SUNDRY NOTICES AND REPORTS ON WELLS

Walker Gas Com A #22

☒ Other APD modif./ Name Change

Amoco Production intends to drill and complete the subject well in the Pictured Cliffs formation. The original APD was filed for the Fruitland Coal. Please review the following attachments which include all modifications to the original APD:

Exhibit 1

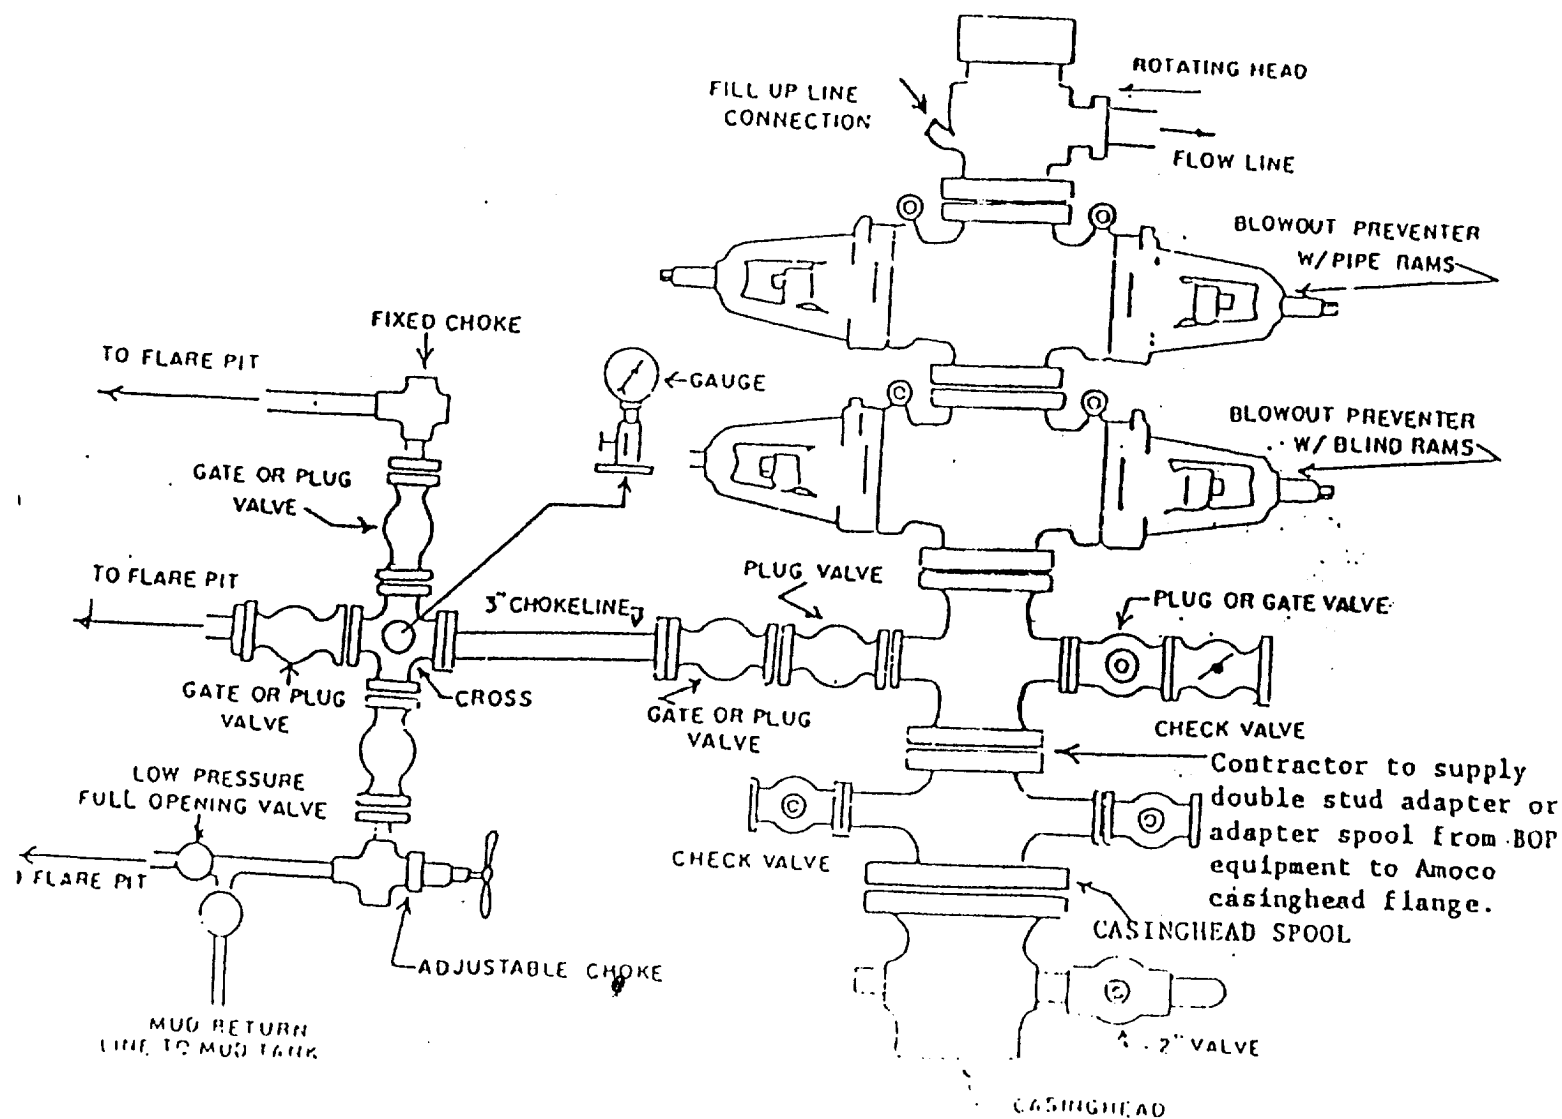
12" nominal, 3000 PSI double ram
preventer with rotating head (see
Exhibit No. 1 - BOPE)

All ram type preventers and related control equipment will be hydraulically tested to 250 PSI (low pressure) and 2000 PSI (high pressure), upon installation, following any repairs or equipment replacements, or at 30 day intervals. Accessories to BOP equipment will include kelly cock, floor safety valves and choke manifold which will also be tested to equivalent pressure.
